## HISTORIC AND DESIGN REVIEW COMMISSION

**HDRC CASE NO:** 2016-295  
**ADDRESS:** 722 S ST MARYS  
**LEGAL DESCRIPTION:** NCB 902 BLK LOT 24 AT 724 ST MARY'S  
**ZONING:** IDZ H HS  
**CITY COUNCIL DIST.:** 1  
**DISTRICT:** Lavaca Historic District  
**LANDMARK:** El Mirador  
**APPLICANT:** Robert Alvarado/Alvarado Builder  
**OWNER:** Sendero Ranch Development LTD  
**TYPE OF WORK:** Installation of entry canopies, window awnings, fencing and entry tile  
**REQUEST:**

**Historic and Design Review Commission  
Design Review Committee  
Report & Recommendation**

HDRC Case# 2016-295

## LOOP WIRE FENCE DETAILS

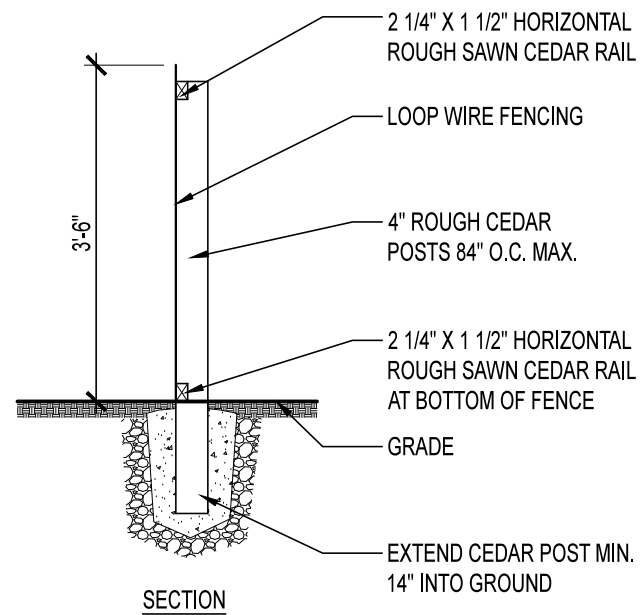
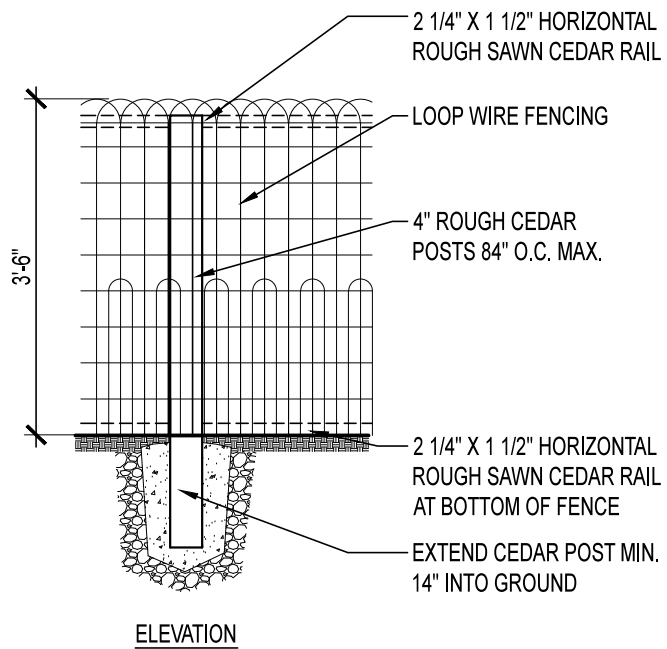
- e. Currently, a wrought iron fence exists in the front yard of the King William Garden House. At the July 15, 2015, HDRC hearing, a new stone wall was approved to replace the existing wrought iron fence. At this time, the applicant has proposed to modify the previous approval to install a 42" tall garden loop wire fence. According to the Guidelines for Site Elements 2.B., New fences and walls should appear to be similar to those used historically within the district, should be no taller than 4 feet in the front where seen from the public right of way and should be constructed of appropriate materials. Staff finds the applicant's proposed fence appropriate and consistent with the Guidelines.

COMMENTS/CONCERNS: MG+TL: NOT USING ASPHALT SHINGLES FOR  
AWNINGS IS BEST. MG: EXISTING WY/FOLIAGE WILL COVER MUCH OF  
THE PROPOSED STRUCTURE. FENCING IS TOO RUSTIC FOR S ST MARY'S.  
ORIGINAL PROPOSED AWNING IS APPROPRIATE -- PRECEDENT IS SET  
FOR AWNINGS / SUN SHADES; ORIGINAL MATERIALS WOULD BE BEST;  
CEDAR SHINGLES. TL: USE OF CEDAR OVER LATILLAS IS APPROPRIATE.  
MG+TL - CEDAR SHINGLES SHOULD BE USED. MG: WIDE FENCE IS  
APPROPRIATE.

1. That the applicant should provide a detail or a sample installation of the proposed cedar shingle awnings and garden loop wire fence prior to the issuance of a Certificate of Appropriateness.

## ENTRY TRELLIS DETAILS

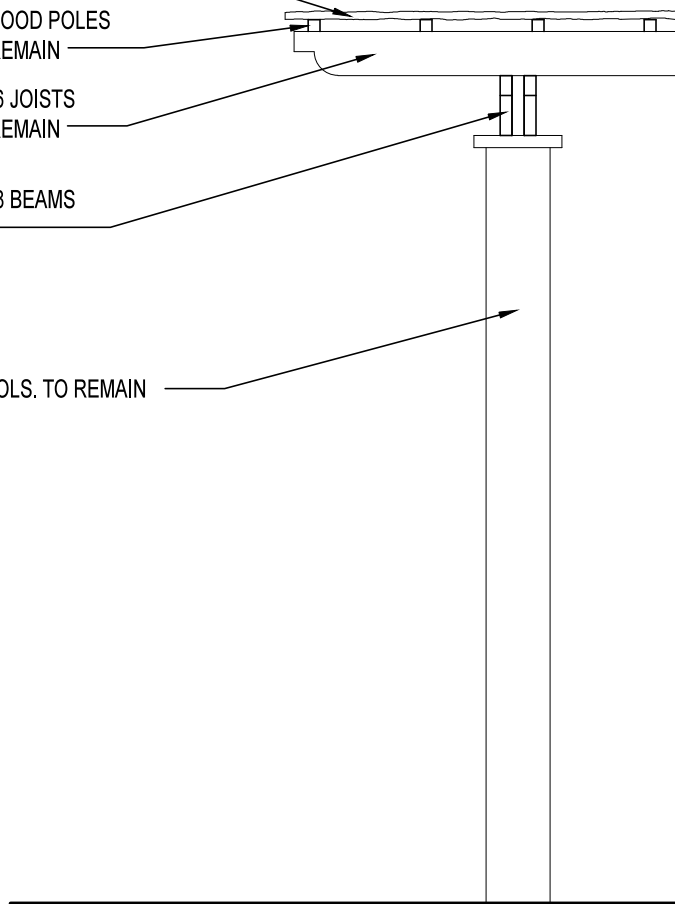
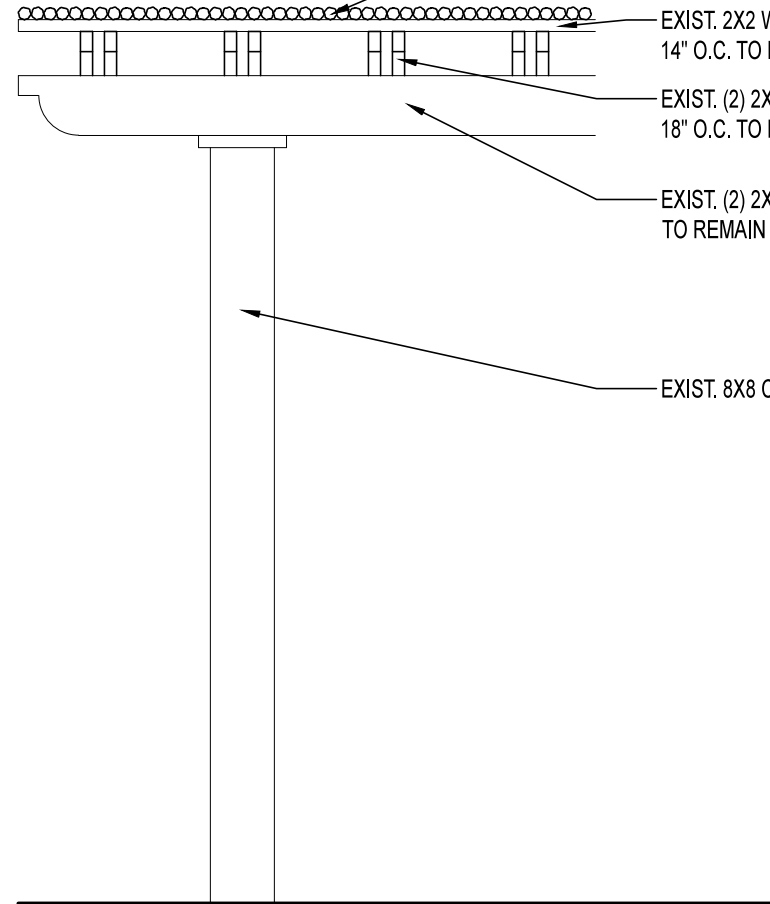
- c. The applicant has proposed to replace the existing corrugated plexiglass entrance covering with a new rough cedar panel covering. The existing entrance canopy structure will remain with only the plexiglass covering being removed. Staff finds the applicant's proposal appropriate.

Staff recommends approval based on findings c through e with the following stipulations:
